**RESOLUTION SETTING HEARING ON REQUEST FROM
KENYON HILL RIDGE, LLC TO REZONE PROPERTY
IN THE VICINITY OF 5066 NORTHEAST 23RD AVENUE (EASTON BOULEVARD)**

Communication from the City Plan and Zoning Commission advising that at their April 5, 2018 meeting, the following action was taken regarding a request from Kenyon Hill Ridge, LLC (owner) represented by David Walters (officer) to rezone property at 5066 Northeast 23rd Avenue (Easton Boulevard) from "A-1" Agricultural District to "PUD" Planned Unit Development. The south 7.135 acres is pending voluntary annexation into the City of Des Moines.

RUBY ROSE RIDGE PLANNED UNIT DEVELOPMENT

LAYOUT PLAN

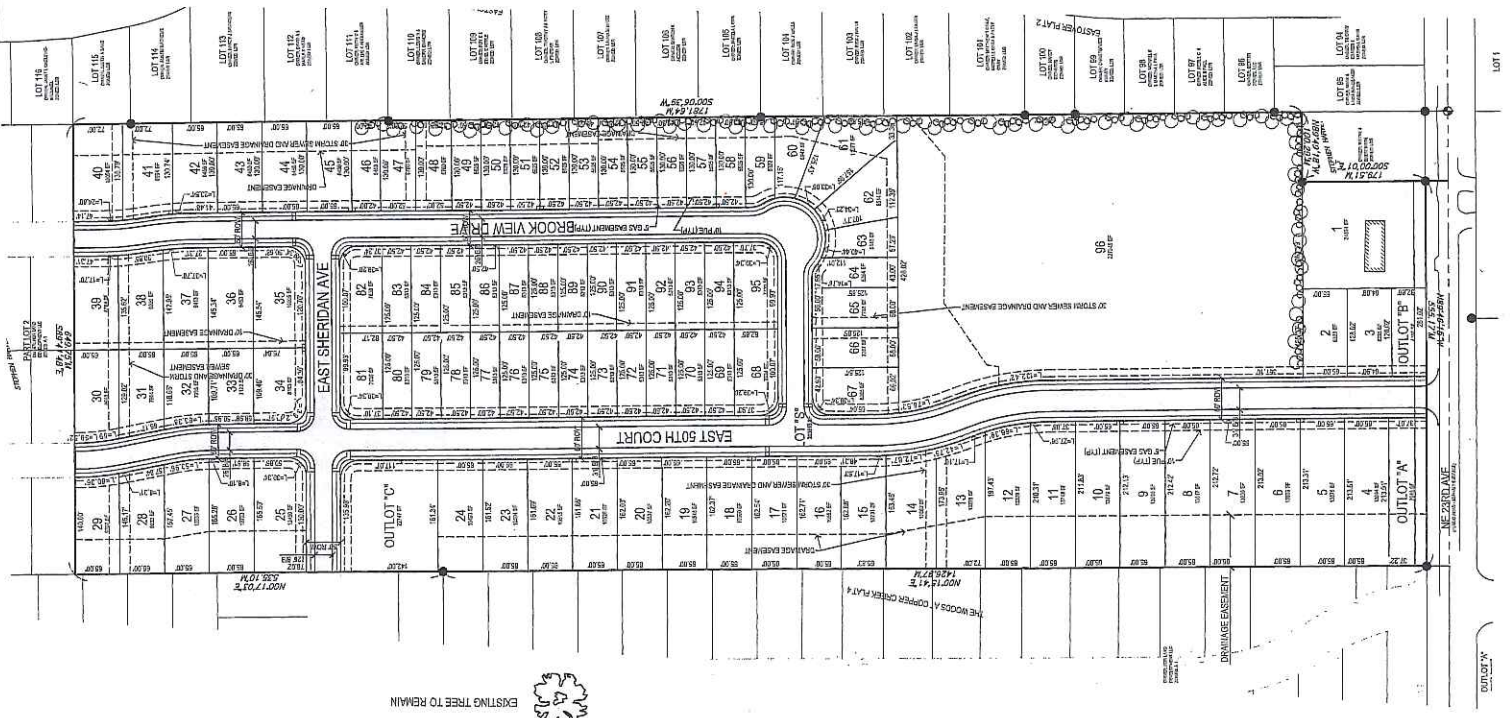
1. Lots 1, 2, & 3 within Area A shall be shifted to be within Area C so that the modified Area C has frontage on NE 23rd Avenue (Easton Boulevard).
2. The maximum net density of Area C shall not exceed 12 dwelling units per acre.

3. Any future development within Area C shall not include any structure that contains more than 12 dwelling units.
4. Any future development within Area C shall be subject to a PUD Development Site Plan as reviewed by the Plan & Zoning Commission to ensure that building designs and site layouts are appropriate and compatible with the surrounding neighborhood.

5. The bulk regulation stating that any bi-attached unit shall have 1,150 square feet of area should be deleted since it conflicts with the requirements contained elsewhere on the PUD Conceptual Plan stating a minimum of 1,200 square feet is required.

6. A note shall be provided to state that an overstory tree in the rear yard of each single-family and semi-detached lot.
7. A note shall be provided to state that each single-family and semi-detached dwelling shall have foundation plantings, including a minimum of five (5) shrubs.

8. A 5-foot wide sidewalk shall be provided within the 30-foot wide storm sewer and drainage easement between Lots 13 and 14, which may require modification to the current storm water management design.
